Attachment 2

Responses to Request for Additional Information Questions

Entergy Nuclear Operations, Inc., (ENO) previously submitted the 10 CFR 50 Appendix G equivalent margins analysis (EMA) in Reference A below under 10 CFR 50.4, as discussed in the Detailed Description section in Attachment 1 of this submittal. In Reference B, ENO received a request for additional information (RAI) concerning the EMA submittal that contained six questions. The ENO responses to RAI questions 1, 3, 4, 5, and 6 were provided in Reference C. The ENO response to RAI question 2 was provided in Reference D.

Figure 5-1(a) - PNP Typical Thermal Transient Axial Stress Profile – Stress versus Time

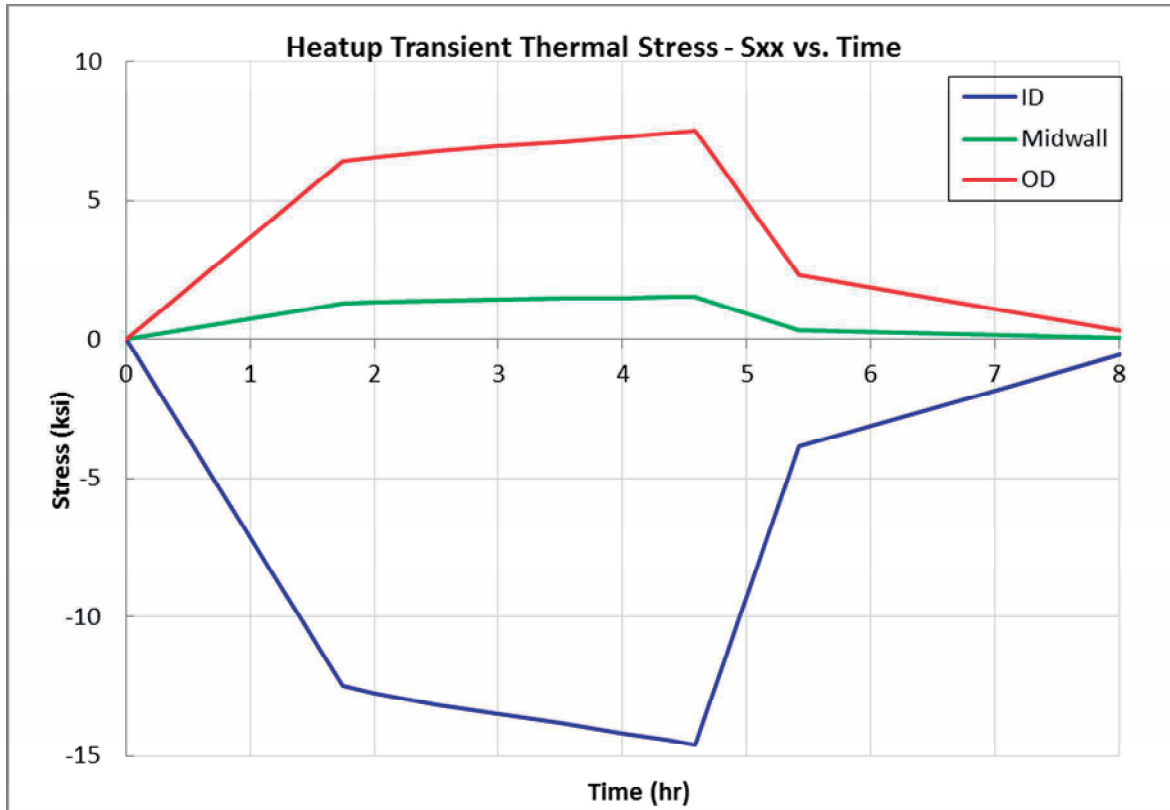
1. *The EMA is based on American Society of Mechanical Engineers (ASME) Boiler and Pressure Vessel Code (Code) Section XI, Appendix K as supplemented by Regulatory Guide (RG) 1.161 "Evaluation of Reactor Pressure Vessels with Charpy Upper-Shelf Energy Less Than 50 Ft-Lb". ASME Code Section XI, Appendix K, Article K-4210 and RG 1.161 both include equations for calculating the stress intensity factor due to radial thermal gradients. In Section 5.1 of the EMA submittal, the licensee discusses through-wall thermal stress and states that typical through-wall stress and stress distribution during a heatup transient are shown in Figures 5-1 and 5-2. But Figures 5-1 and 5-2 of the EMA submittal do not show these stresses as discussed. Provide figures showing typical through-wall stress and stress distributions during a heatup transient to support the discussion in paragraph 5.1 of the EMA submittal.*

Figures detailing typical heatup thermal axial stress and typical through-wall axial stress for the PNP reactor vessel used in the equivalent margins analysis (EMA) submittal are provided below.

WCAP-17651-NP New Figure 5-14: Applied J-Integral versus Crack Extension for Axial Flaw – 1/4t, Level A and B

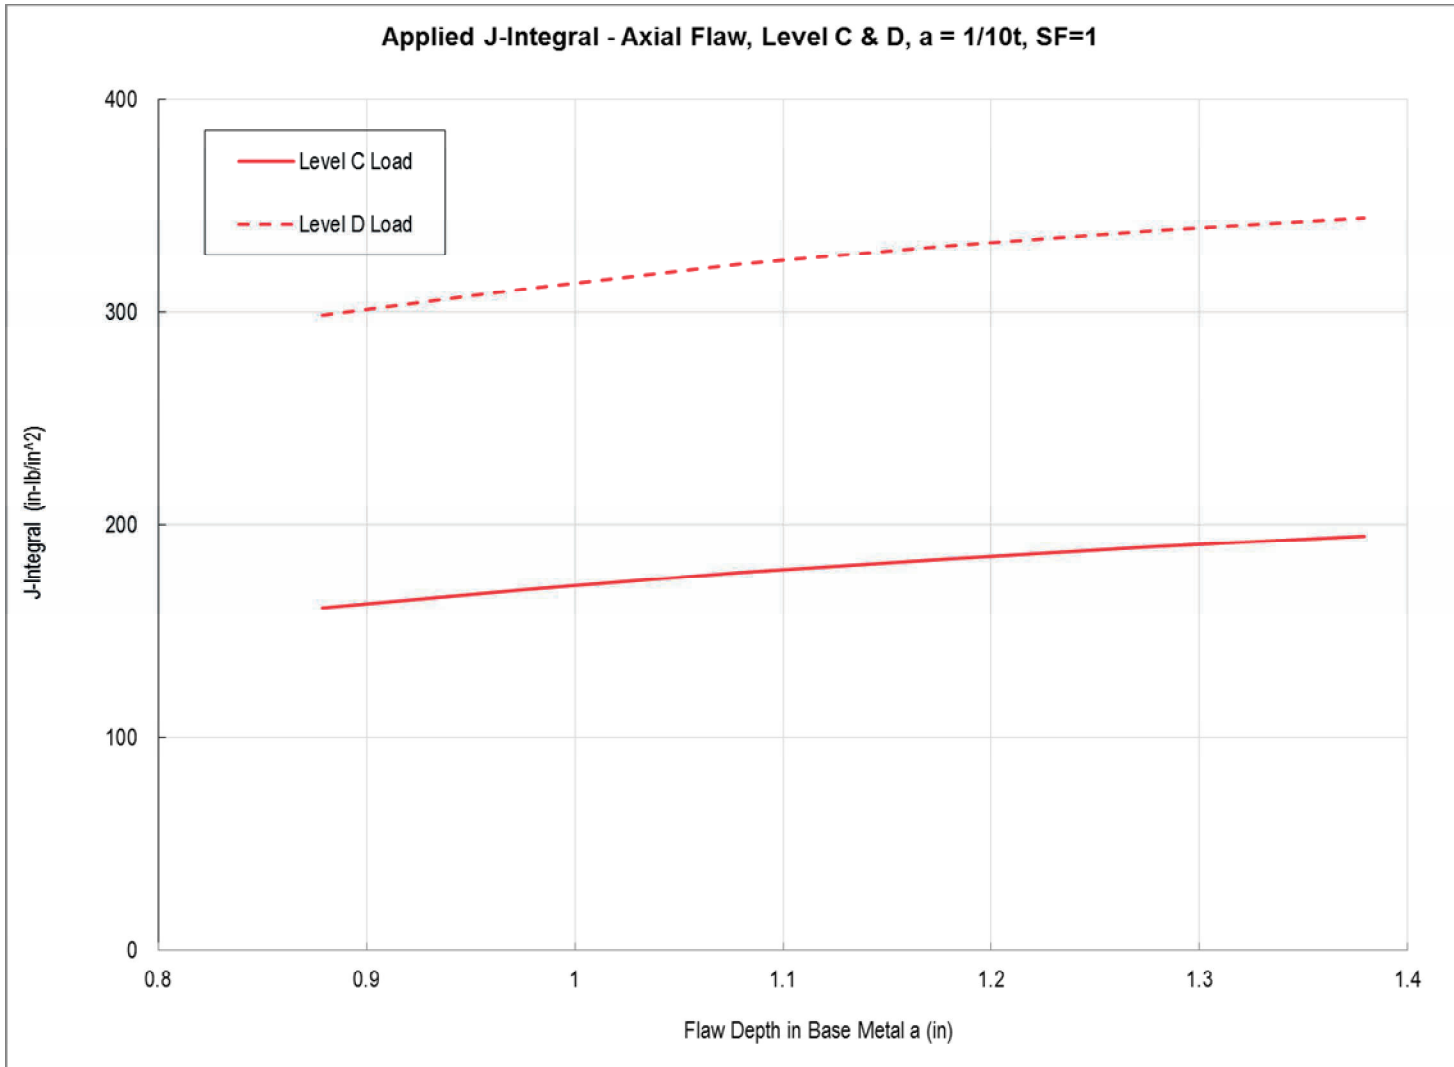
- Section 5.1 states, "Only circumferential base metal flaws are considered in this analysis, because only the "weak" orientation USE is projected to drop below 50 ft-lbs as described below." Please demonstrate that assuming a circumferential flaw in the base metal with the weak Charpy V-Notch (CVN) value in the EMA is more limiting than assuming an axial flaw in the base metal with the strong CVN value. Please note that the significantly greater applied J integral associated with the axial flaw may challenge the fundamental assumption in the EMA submittal.

New Table 5-8 details the axial flaw safety factors for all transients, Levels A, B, C and D, with consideration of the Regulatory Guide 1.161 J-R model and limiting EOLE USE equal to 73 ft-lbs per WCAP-17651-NP. New Table 5-9 details the axial flaw safety factors for all transients, Levels A, B, C and D, with consideration of the V-50 plate data adjusted to the L-T orientation. New Figures 5-14 and 5-15 detail the applied J-Integral versus crack extension for axial flaws at $1/4t$ for Level A and B transients and applied J-Integral versus crack extension for axial flaws at $1/10t$ for Levels C and D transients, respectively. New Figure 5-16 details the axial flaw J-Integral versus crack extension at $1/4t$ for Level A and B transients for base metal with Regulatory Guide 1.161 model J-R curves and V-50 plate data included. New Figure 5-17 details the axial flaw J-Integral versus crack extension at $1/4t$, pressure = 2.75 ksi, and a 100°F/hr cooldown transient for base metal with Regulatory Guide 1.161 model J-R curves and V-50 plate data included. Lastly, new Figure 5-18 details the axial flaw J-Integral versus crack extension at $1/10t$ for Levels C and

WCAP-17651-NP, Revision 0, Updated Figure 5-2 with Corrected, Limiting, Level C and D Transients

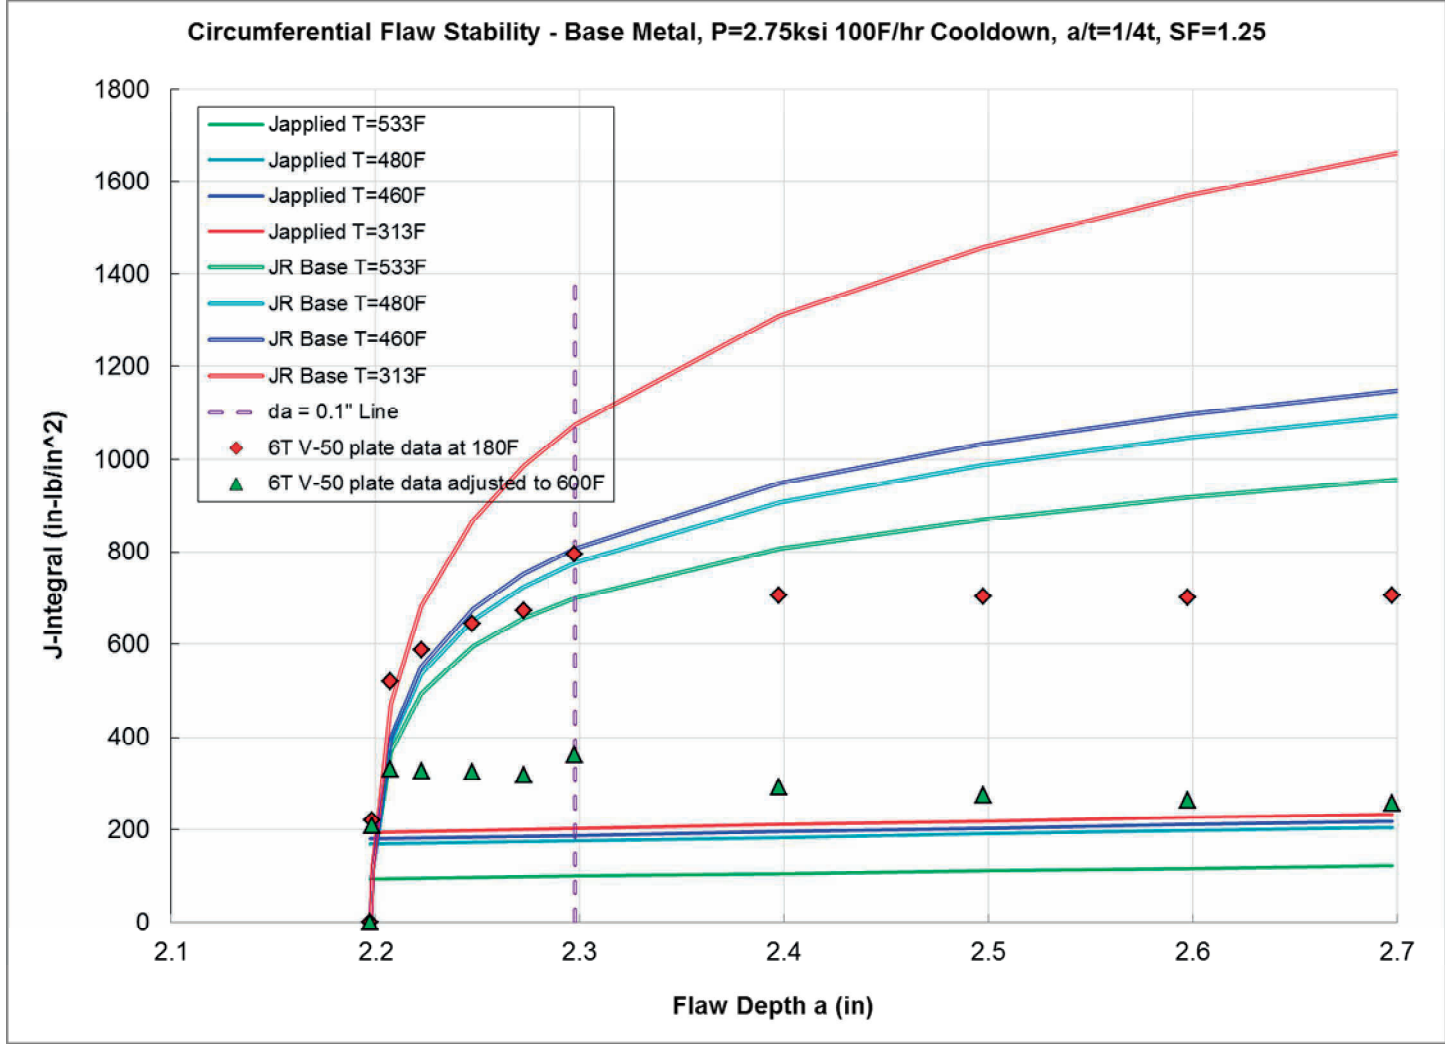
3. *The applied J-integral values for the circumferential flaws for all Level A and B service level conditions are shown in Figure 5-1, and the applied J-integral values for the circumferential flaws for Level C and D service level conditions are shown in Figure 5-2. Since Section 5.1 provides very limited information regarding the applied J-integral calculations, please confirm that the calculations underlying Figures 5-1 and 5-2 are based on the formulas in RG 1.161, "Evaluation of Reactor Pressure Vessels with Charpy Upper-Shelf Energy Less Than 50 FT-LB." If not, please describe, in addition to your response to RAI-1, your plant-specific calculations to support their acceptance in this application.*

Westinghouse discovered during the development of this RAI response that the Level C and D loading J-applied curves plotted in WCAP-17651-NP, Figure 5-12, were not the most limiting case. This error also propagated onto Figures 5-2 and 5-13 in the WCAP. This has been updated in the attached figures as part of this RAI response. Note that the conclusions to the report, including the safety factor determination, are unchanged; only

WCAP-17651-NP, Revision 0, Updated Figure 5-9 with V-50 Plate Data Included

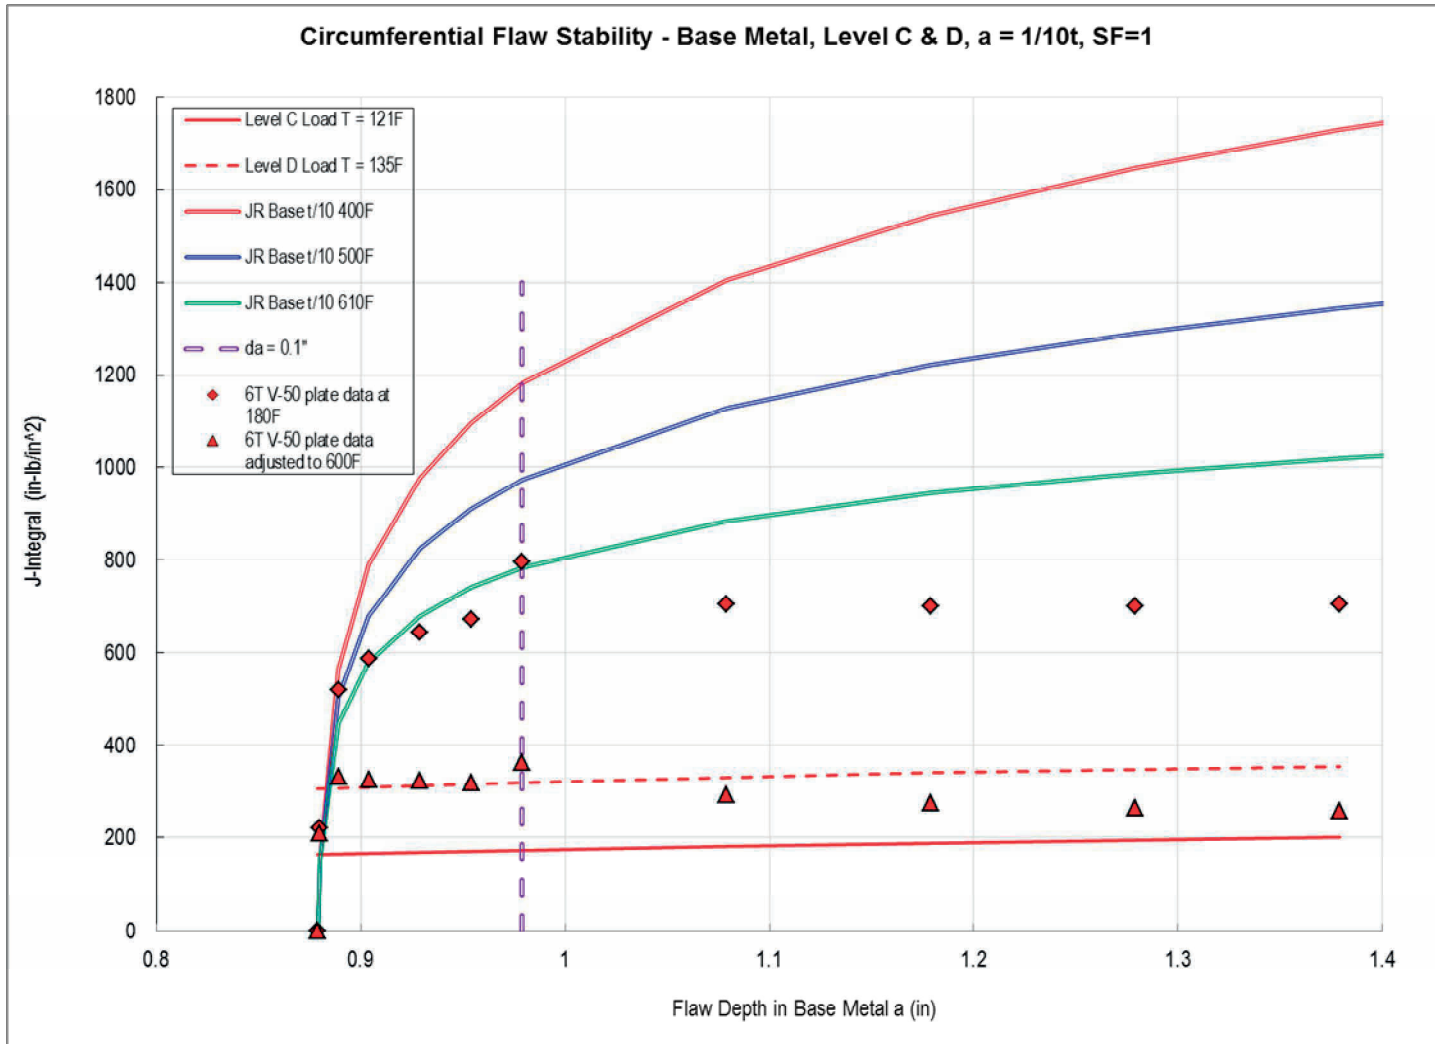
5. *Section 5.2 provides justification for using the high-toughness/low-sulfur model from RG 1.161 in the proposed EMA for the high-sulfur plates, and Section 5.3 provides the corresponding EMA results. When the high-sulfur model (e.g., for the 6T specimen) of NUREG/CR-5265, "Size Effects on J-R Curves for A 302-B Plate," is used, please demonstrate that*
 - *The updated safety factors (see Table 5-3), after adjusting for temperature, will still be greater than 1.15.*

- *The updated applied J/J-R curves (see figures 5-8, 5-9, and 5-12), after adjusting for temperature, will still show that $dJ_{\text{applied}}/d_a < dJ_{\text{material}}/d_a$ at $J_{\text{applied}} = J_{\text{material}}$.*

Updated Figures 5-9 and 5-12 with the V-50 plate data are provided below, along with added Tables 5-4 and 5-5 showing the Level C and D safety factors, respectively. Table 5-6 was added, which demonstrates the available margins on pressure loading with the V-50 plate data, adjusted for temperature, with consideration of all service loadings, Level A, B, C and D. The minimum safety factor (SF) with consideration of the V-50 plate data and the PNP-specific J-applied values is 1.5, which is above the minimum required SF of 1.15 per RG 1.161.

Figure 5-8 from WCAP-17651-NP, Revision 0, along with the updated Figures 5-9 and 5-12 below, all demonstrate that at $J_{\text{applied}} = J_{\text{material}}$, $dJ_{\text{applied}}/d_a < dJ_{\text{material}}/d_a$, is satisfied for all three cases (i.e., the slope of the J_{applied} is smaller than the J_{material} at the point of intersection).

WCAP-17651-NP, Revision 0, Updated Figure 5-12 with V-50 Plate Data Included and Corrected, Limiting, Level C and D Transients

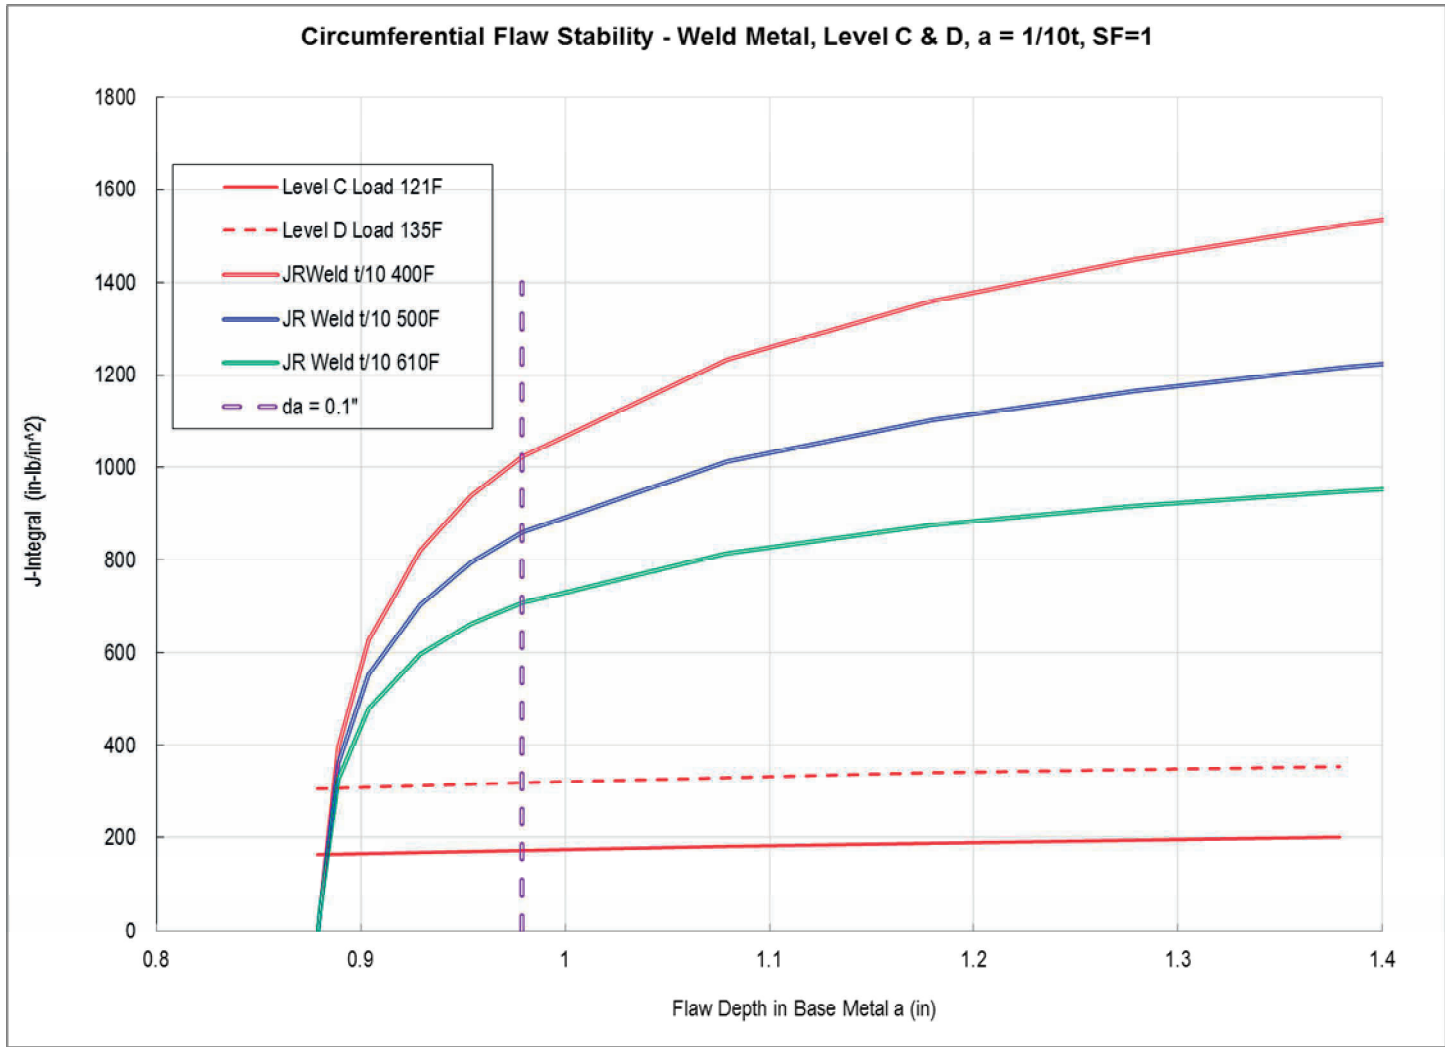
6. *Section 6 presents conclusions of this submittal. For Service Level C condition with 400°F/hr cooldown, it is concluded that, "The equivalent margins analyses for the plate materials are acceptable and bounded by the conservative test data reported in NUREG/CR-5265 in all cases for the Level C transient." This conclusion was repeated later for Service Level D condition with 600°F/hr cooldown, with "C" in the quote replaced by "D." Plot the relevant NUREG/CR 5265 6T data in Figure 5-12 and provide sufficient justification to support your conclusions.*
